**LIST OF OVERHAUL MODIFICATIONS  
DIRECT CRANKING ELECTRIC STARTER  
TYPES 36E02-1A, 756-10C, 756-22C AND 756-56C  
(ECLIPSE)**

(This EO replaces EO 40-70BD-6B dated 15 Feb 62)

## SPLINE NUT PARTS 121252 TO 646474

(This EO replaces EO 40-70BD-6B/4 dated 12 Dec 61)

Figure 1

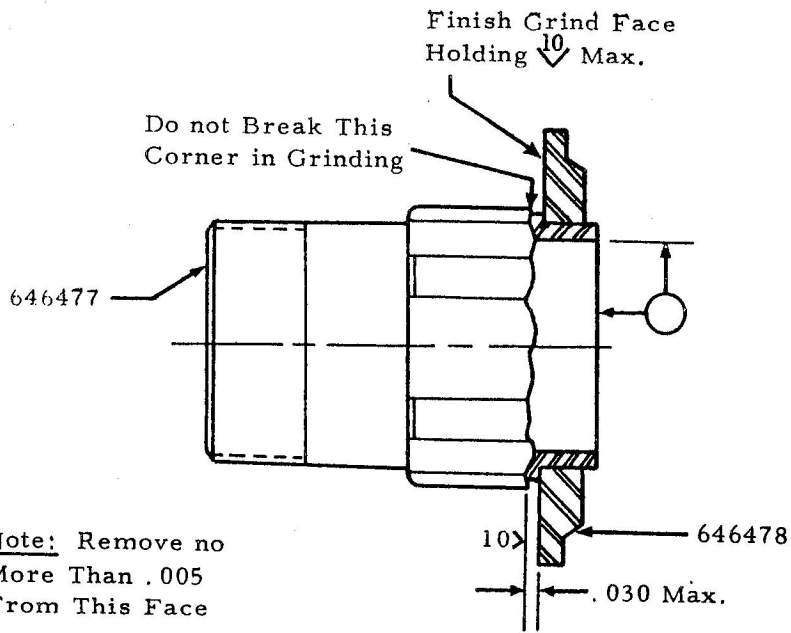
- (e) Upon removal and inspection, spline nut Part 121252 can be reworked as follows:
  - (1) Copper plate all over.
  - (2) Anneal.
  - (3) Machine to diameter shown in Figure 1 for brazing.
  - (4) Braze and harden with permabraz 630 1/32 dia. wire using type B-1 flux. Oil quench from braze heat, temper to 38-42 Rc.
  - (5) Strip copper plate.
  - (6) Inspect R/C.

1.496 Dia. to be Concentric  
With Loc. Dia. Within .005 FIR  
Remove Burrs

.010 Max Rad.

Figure 3

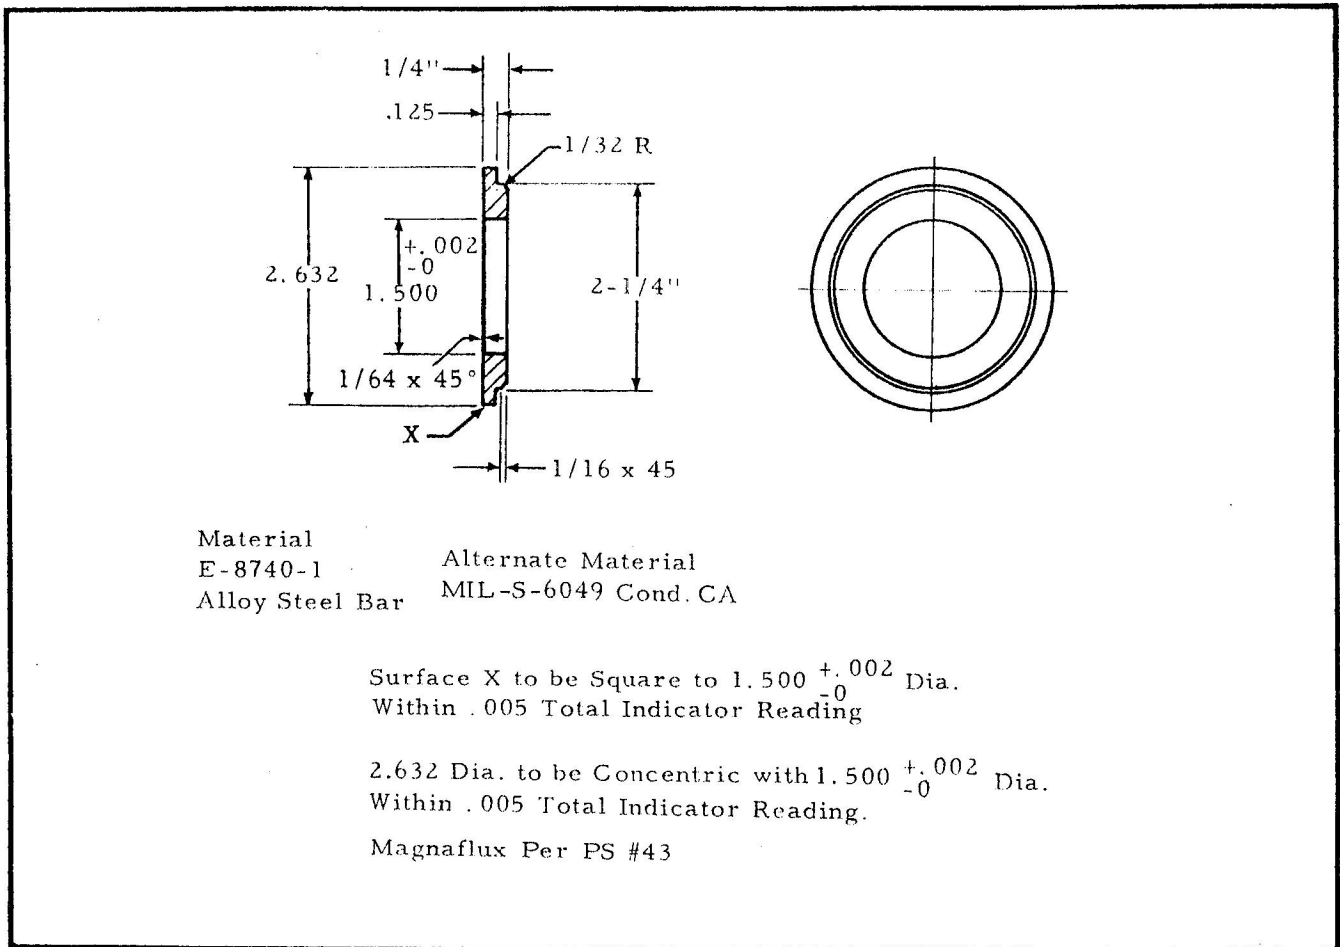
- (7) Finish grind face, holding  $\sqrt{10}$  Max.
- (8) Tumble to produce  $\sqrt{8}$ .
- (9) Magnaflux per P.S. 43.
- (f) Locating ring Part 646478, may be fabricated by using dimensions shown in Figure 3.
- (g) Assemble locating ring Part 646478 to reworked spline nut as shown in Figure 2.
